RAU CONSTRUCTION COMPANY  
9101 WEST 110<sup>TH</sup> STREET SUITE 150  
OVERLAND PARK, KANSAS 66210  
Phone: 913-642-6000 Fax: 913-642-6031

The Grand Reserve  
Addendum for Bidding #2

**RE: FORMER FEDERAL RESERVE BUILDING  
925 GRAND BLVD  
KANSAS CITY, MO**

8. West Elevation: Close-  
up of photo #7.

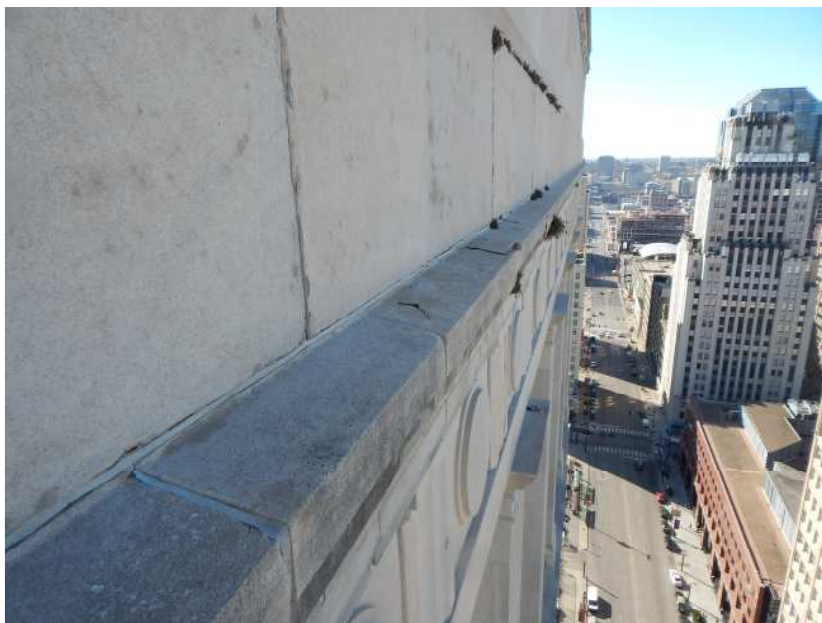
7. West Elevation:  
Corroded dowel in stone  
panel causing spalling of  
stone.
